Meeting held: Saeed Mahmood / Mark Goodwin (Landscape Officer)
10th August 2026, 2pm (online Teams call)

PL/2025/09623 - Development site known as 'Land off High Street, Sutton Benger'.

Proposal: *Application for the Approval of Reserved Matters (Appearance, Landscaping, Layout and Scale) for the Erection of 60 Dwellings, Public Open Space, Landscaping and Associated Infrastructure following Outline Planning Permission PL/2023/06204.*

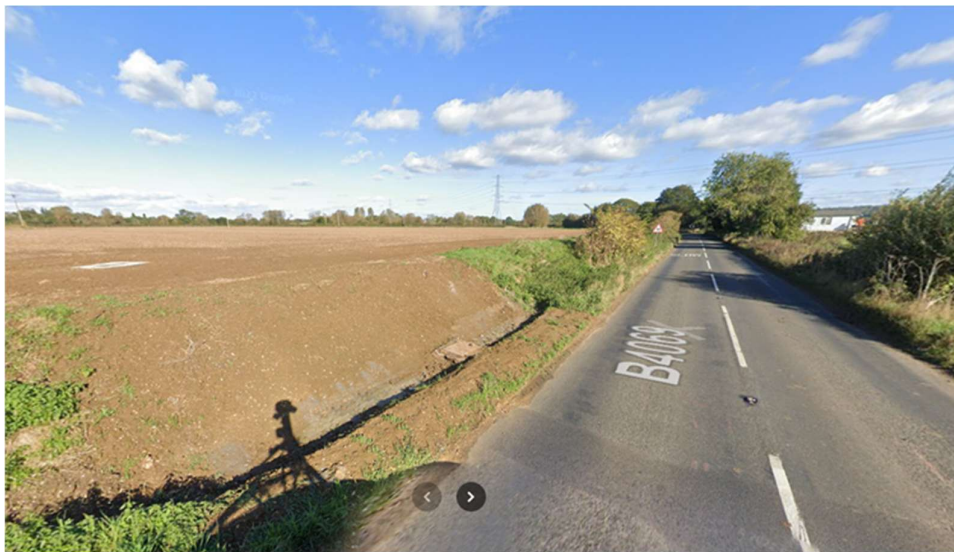
Boundary treatments; if you look along the existing high street, you see the common unifying use of natural stone in property boundary frontages, subsequently we have received an email from UD officer stated:

Having reviewed the boundary treatments plan, the applicant is including 'Natural Stone Dwarf Wall / Cock & Hen copings - Overall 0.9m High' to the entrance properties and which turn the corner into the main access street, however they seem to have omitted this from plot 29. Hopefully a simple draughting mistake which should be rectified. Applicants to update drawings

The boundary screen wall material is not specified this should be conditioned.

Examples of boundary wall treatments in the vicinity of the site:

SM to follow-up and check the drawings, the boundary treatment issue has been addressed or will be, if condition may be required.

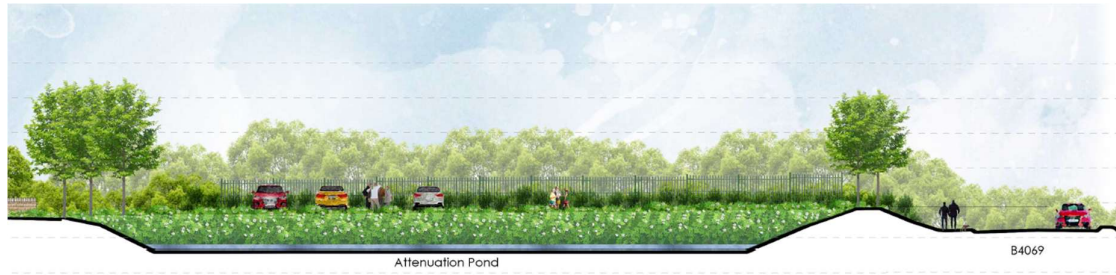
The landscape officer requested the submitted sections which the applicant has additionally provided, A, B & C, due to concerns regarding boundary treatment/safety along the southern edge of the new POS, the unguarded steep bank profile, and proximity to a 50 mph road.

Sections A & B (below) show no guard fencing /hedge or wall along base or top of the southern edge of the new public open space, adjacent to the new set back slope fronting onto the B4069. This raises serious safety concerns as anyone could potentially fall into the highway into oncoming traffic of around 50 mph.

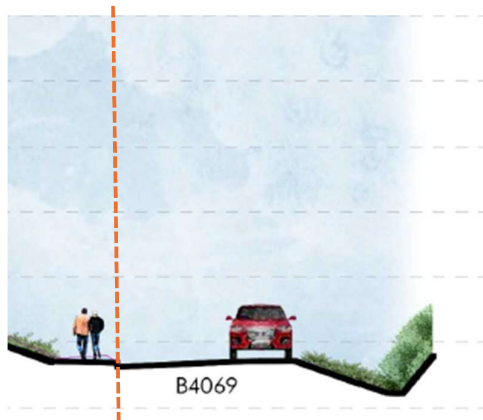
Section C (above) is incorrect as it shows pedestrians and a new footway running east of the proposed vehicular site entrance. No footway is planned, proposed or requested to run east of the new site entrance fronting the B4069.

The footpath runs from the highway entrance to the west. It doesn't continue to the east, which is where this section is taken through. Section C-C requires amendment.

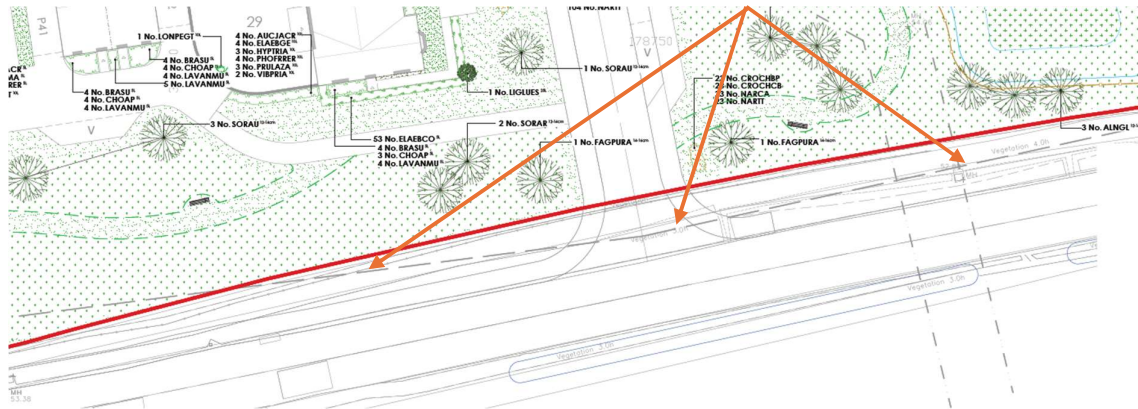
There is a small shallow ditch within the existing roadside grass verge, where the proposed footway is planned (see below), red dashed line inserted by Saeed Mahmood, denoting approximate line of this shallow ditch:

This may not have been picked up by Highways and Drainage colleagues, but this needs to be suitably addressed now, at the detailed reserved matters planning stage, as this potentially has land take/ layout implications.

This local road often seasonally floods alongside the lower areas of land next to the river. It could well be that the existing shallow roadside ditch provides a swale type function from the higher land to intercept surface water run-off from the higher field areas, or acts as a highway drain, possibly both. There is clearly an existing shallow ditch running along at least part of the southern edge of the site which is not included on the submitted sections. This shallow ditch may potentially cross under the B4069 via a culvert into the other deeper ditch on the other side of the road, or it may continue to drain down to the river on the same side as the site.

You can just about see this ditch as a faint dashed line on the landscape drawing (see below), please see the red arrows inserted by Council's Landscape Officer

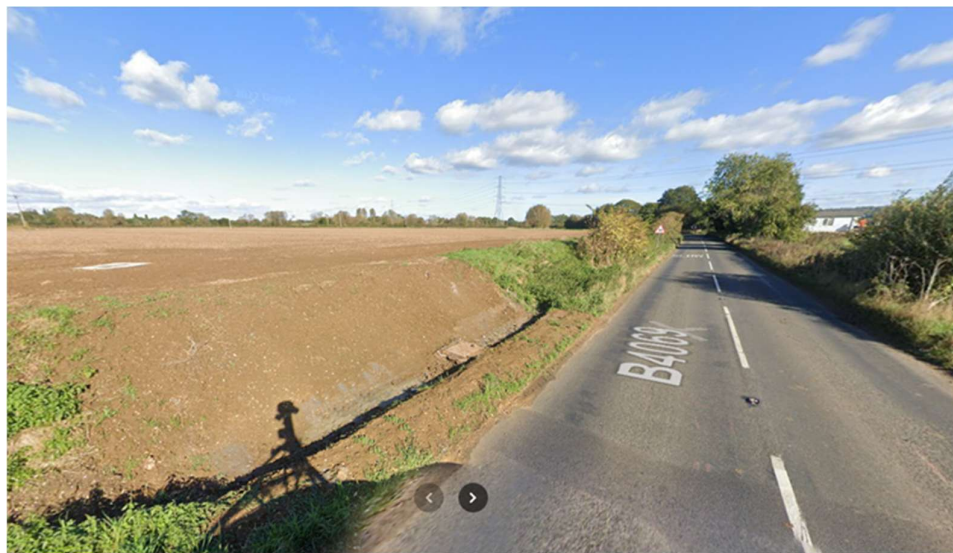
If you look at the October 2021 Google Street View (below), which was taken shortly after Wessex water completed the sewer replacement across the site, the image shows the reinstated bank profile including a shallow ditch which runs eastwards, potentially to meet up with a culvert crossing the B4069 into the deeper ditch running along the opposite side of the road.

Wessex Water re-profiled this slope after their works to clearly include a shallow ditch, which they wouldn't have done unless there was an existing shallow ditch present.

The applicant should confirm at least in principle what they are proposing here i.e. is it to recreate a roadside ditch to intercept surface water flow paths from the higher land, and preventing this from running across the new footway and road? or do they propose new road gullies between the road and new footway to an existing piped drainage system? or both?

This aspect of the scheme should be further checked with the council's drainage and highway engineers or possibly with the applicant's engineers in the first instance. What is the applicant's proposal for surface water drainage along the southern boundary of their site? Will this slope require setting further back into the site (more than currently allowed to accommodate just the new footway) to provide a replacement linear drainage feature along the back edge of the proposed footway?
